Access Compliance Report

Public Rights-of-Way

(Curb Ramps)

Intersection ID: 10039791	Main Street: TOLLESON_AV	Cross Street: N/A	Location: SW
ADA ID: B4D2269F3614	Ramp Type: PerpDiag	Initial Pass/Fail: Fail	Overall Compliance: No
Severity Score: 13.75			
Codes/Mitigation Info/Possible Solution		Field Measurements/Component Compliance

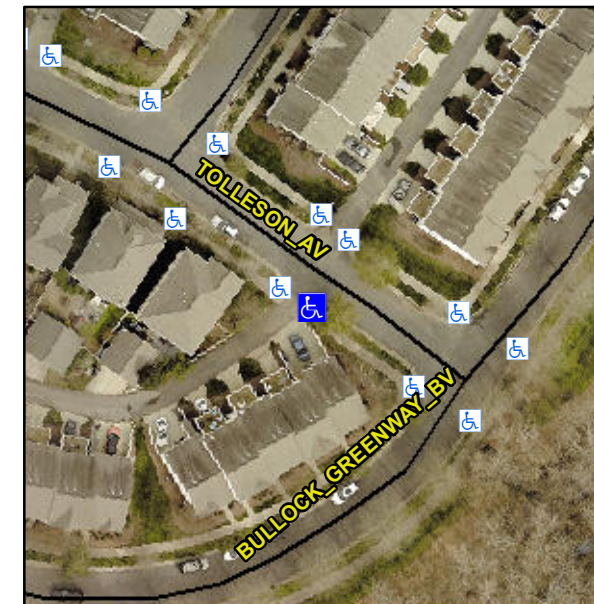
Not Found, R304.2.2, R304.5.3

Compliance	Description	Data	Compliance	Description	Data
N/A	Ramp Length (in)	32.0	No	Ramp Slope (%)	8.5
Yes	Ramp Width (in)	65.0	No	Ramp XSlope (%)	2.3
N/A	Flare Type LT	N/A	N/A	Flare Type RT	N/A
N/A	Flare Slope LT (%)	N/A	N/A	Flare Slope RT (%)	N/A
N/A	Flare Traversable LT?	N/A	N/A	Flare Traversable RT?	N/A
N/A	Landing Length (in)	N/A	N/A	DWS Provided?	N/A
N/A	Landing Width (in)	N/A	N/A	DWS Contrast?	N/A
N/A	Landing Slope (%)	N/A	N/A	DWS Length (in)	N/A
N/A	Landing X Slope (%)	N/A	N/A	DWS Full Width?	N/A
N/A	Landing Curb? (Y/N)	N/A	N/A	DWS Offset (in)	N/A
N/A	Shared Landing?	N/A			
N/A	Gutter Ponding?	N/A	N/A	Gutter Slope (%)	N/A
N/A	Gutter Lip Ht (in)	N/A	N/A	Gutter X Slope (%)	N/A
N/A	Painted X Walk1?	No	N/A	Painted X Walk2?	No
	X Walk 1 Direction	To NE		X Walk 2 Direction	To NW
N/A	X Walk 1 Width (in)	N/A	N/A	X Walk 2 Width (in)	N/A
	X Walk 1 Slope (%)	1.3		X Walk 2 Slope (%)	1.1
	X Walk 1 X Slope (%)	1.1		X Walk 2 X Slope (%)	1.0

N/A	Ramp inside XWalk1?	N/A	N/A	Ramp inside XWalk2?	N/A
	Road Slope (%)	0.3	N/A	Clear Space?	N/A
	Road X Slope (%)	4.6	N/A	Clear Space to XWalk (in)	N/A
N/A	Any Obstructions?	N/A	N/A	Storm Grate/Utility Hazard?	N/A
	Obstruction Type			Storm Grate/Utility Type	
		N/A			N/A
		Yes		Surface Condition? (G/P)	Good

Remove & Replace Curb Ramp With Two New Directional Ramps or Equivalent.
